# **Response to Michigan Department of Environmental Quality Comments dated May 9, 2016 on the Back Forty Project Mine Permit Application**

**Project I.D.: 14A021**

**Aquila Resources Inc.  
Stephenson, Michigan**

**June 2016**

Figure 94-1

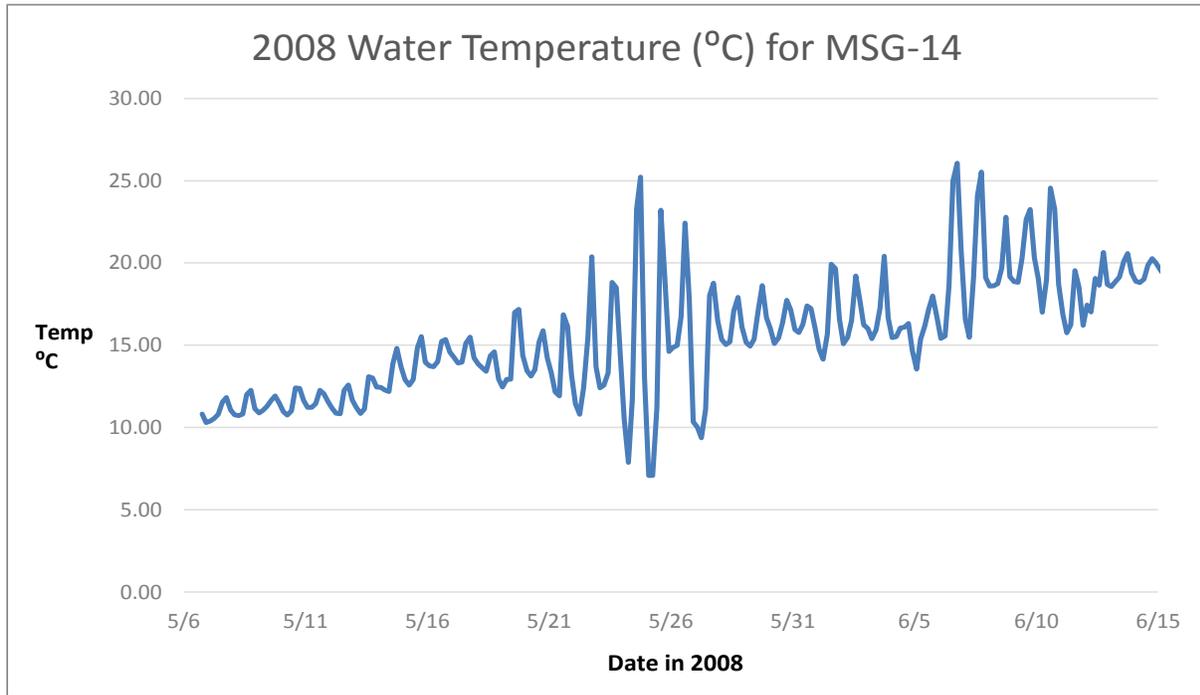
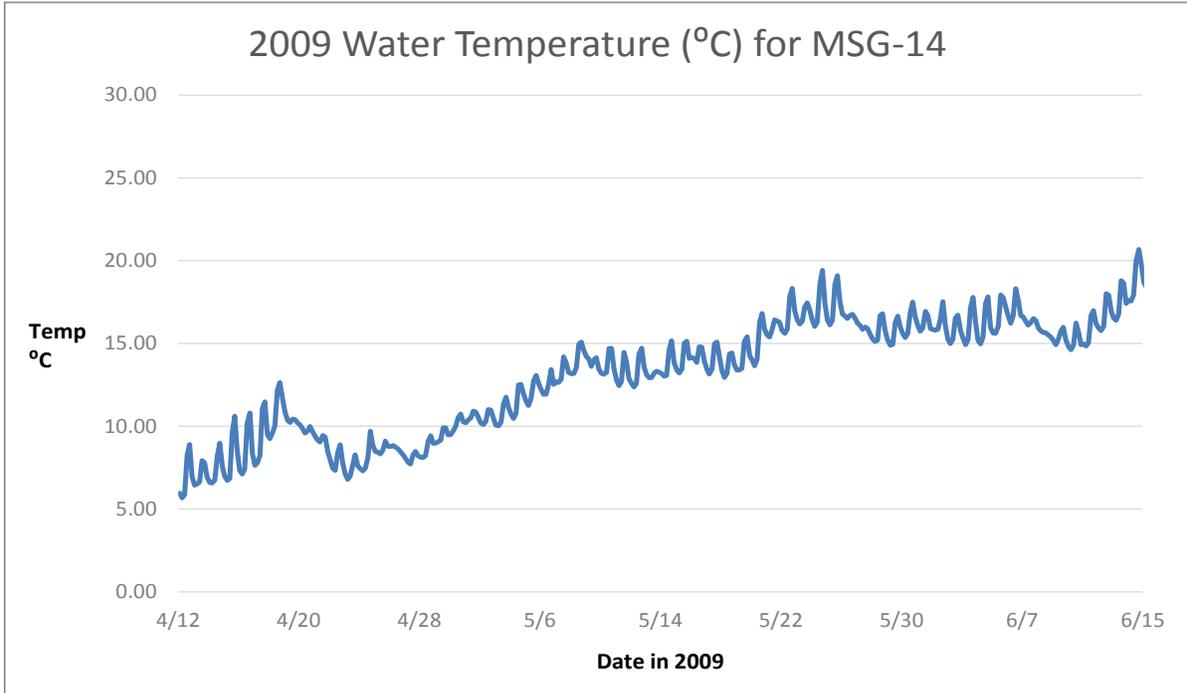
*EIA, Volume IIG, Appendix E-1, Lake Sturgeon Early Life Stage Investigation: Figure 2 is described showing flow and temperature data but only flow is shown. What was the temperature at this location during deployment for 2008?*

Only flow data is recorded at White Rapids Dam. In 2009 there was some temperature data from KOSS, Michigan (MI) (USGS site), however, it does not seem to be available any longer on the USGS site for 04066800. A site below White Rapids Dam - 04067500 near McAllister, Wisconsin does have temperature but only since 2011. Attachment 94 contains Figures 94-1 and 94-2 that provide a water temperature plot containing the temperature data for the MSG-14 2008

BACK FORTY PROJECT	
<b>FIGURE 108-1</b>	
<b>EROSION CONTROL PLAN</b>	
<b>OPERATIONS PHASE</b>	
Scale:	AS SHOWN
Date:	MAY, 2016
Drafted By:	MRS
Project No.:	14A021

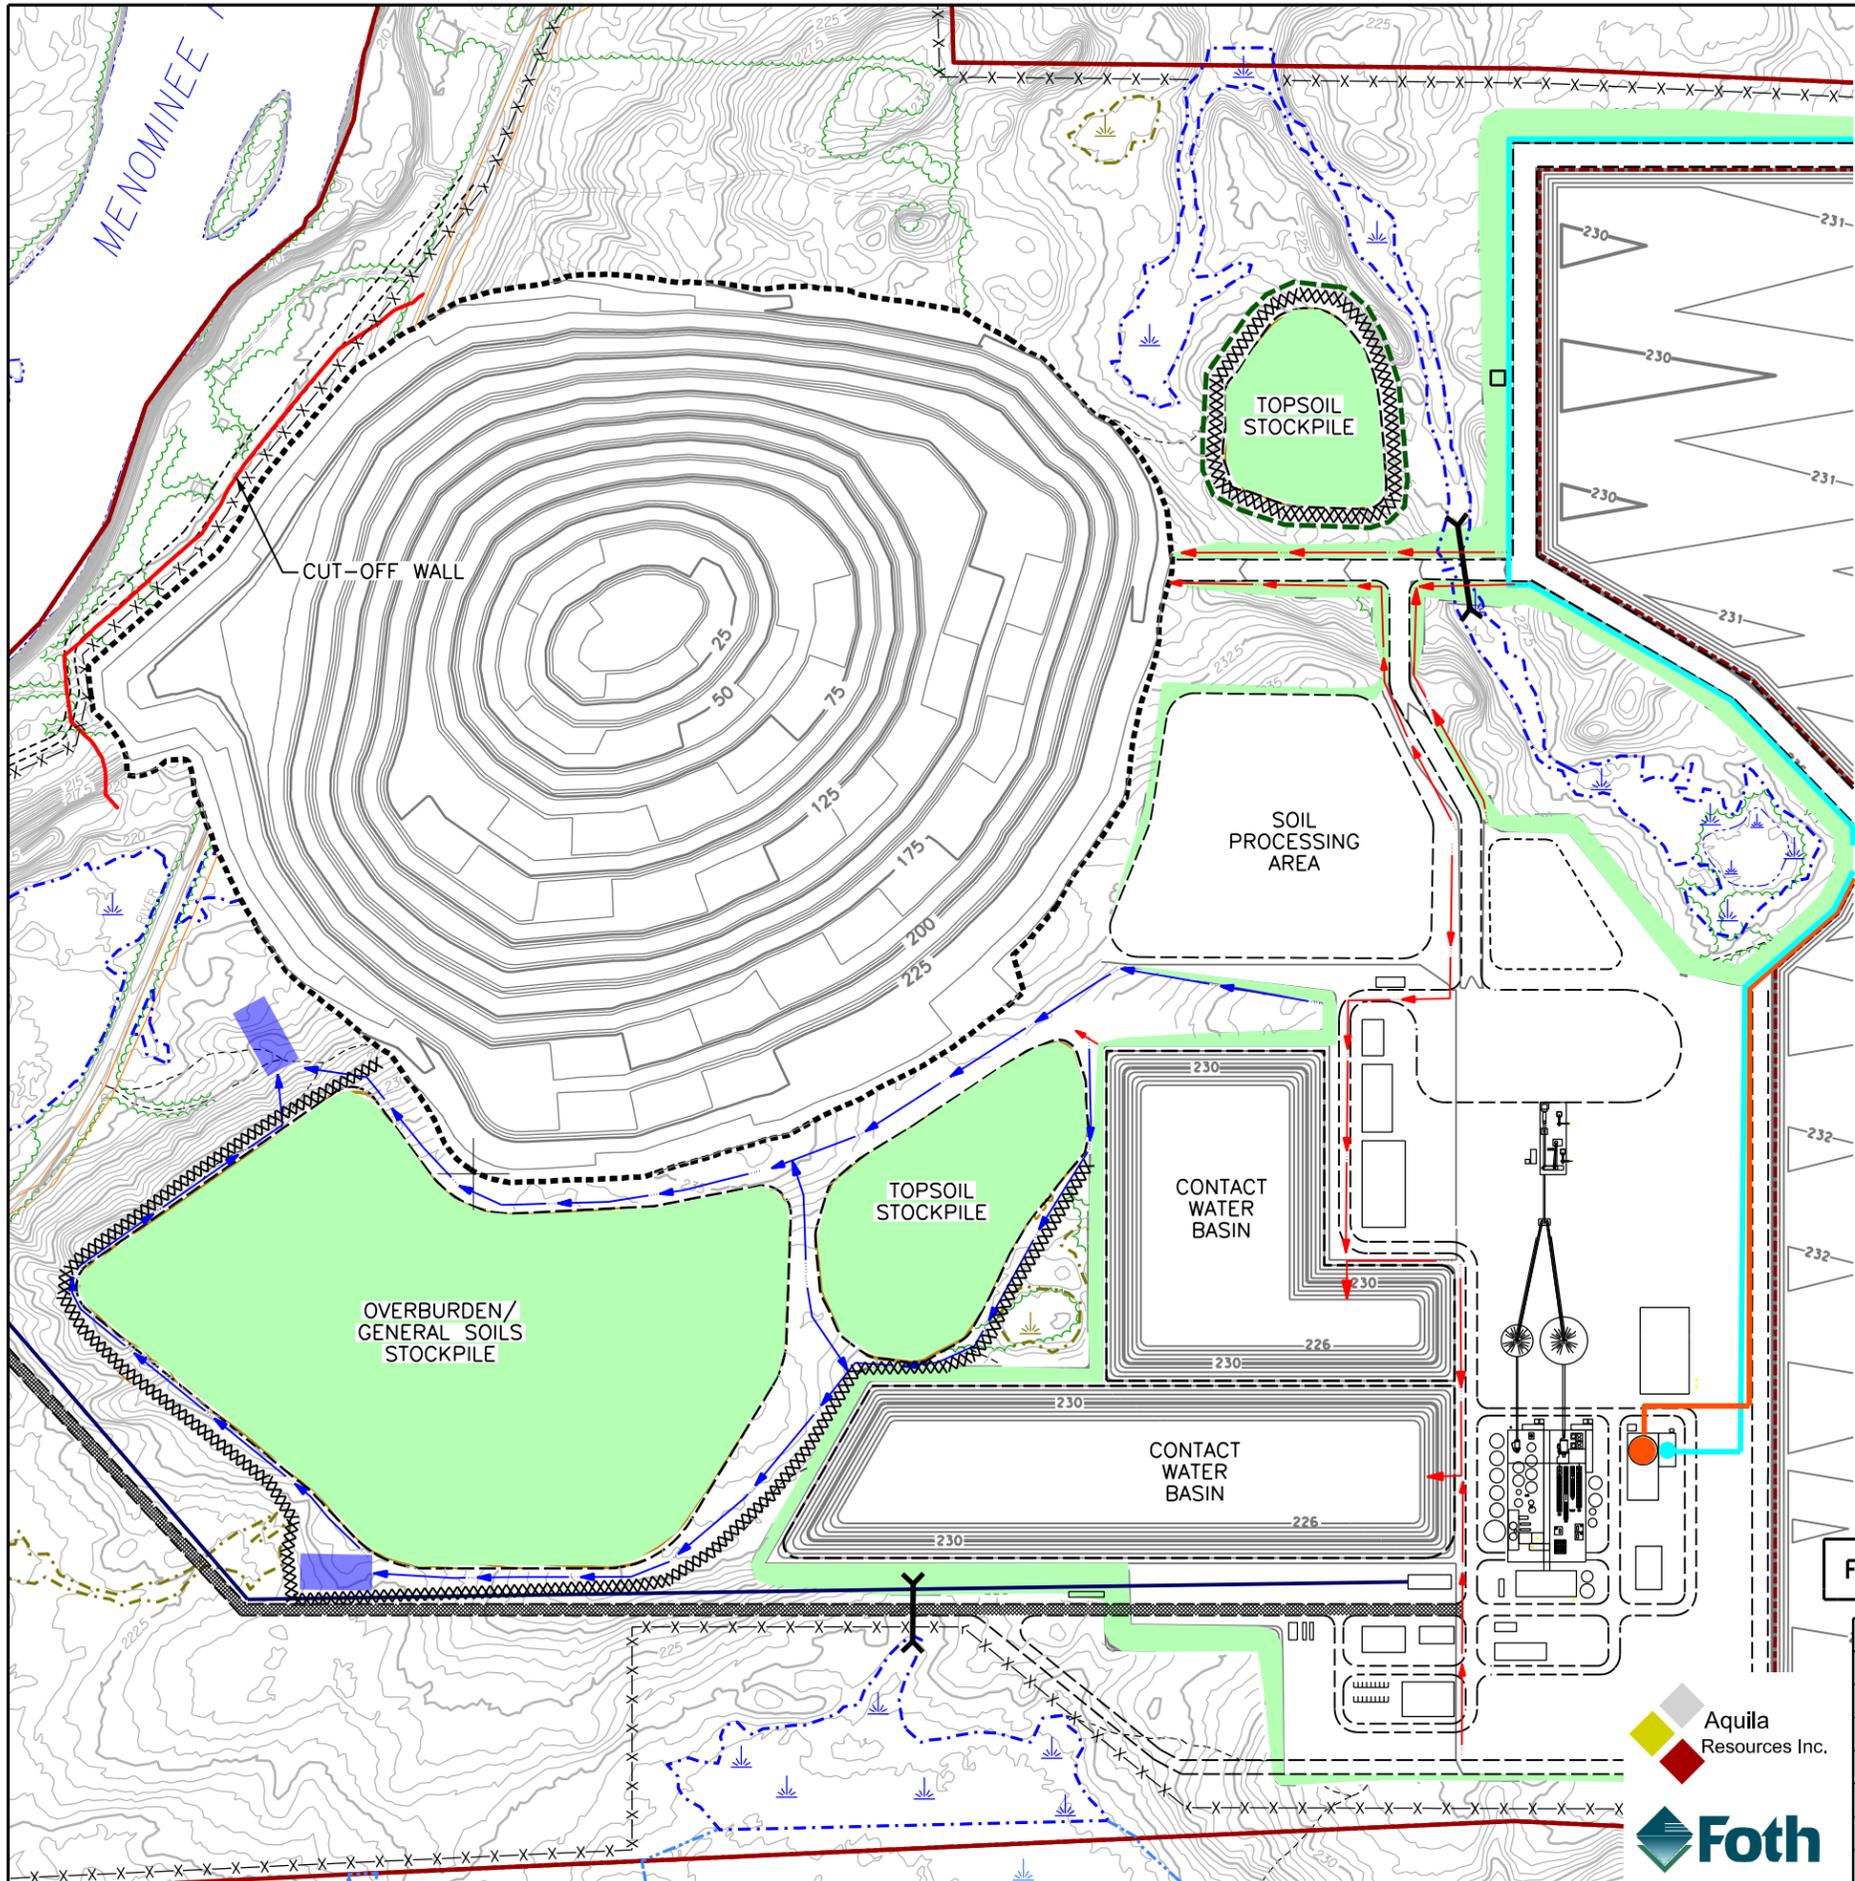
*Figure 2-7, Erosion Control Plan Operations Phase, shows a symbol in the legend for contact water drainage ditches. Since this symbol does not appear on the map, clarification is needed as to whether drainage ditches in the contact area are proposed, and if so, Figure 2-7 needs correction with the location(s) included, preferably at an easier to read scale.*

New Figure 108-1 in Attachment 108 shows the contact water drainage ditches within the contact area.
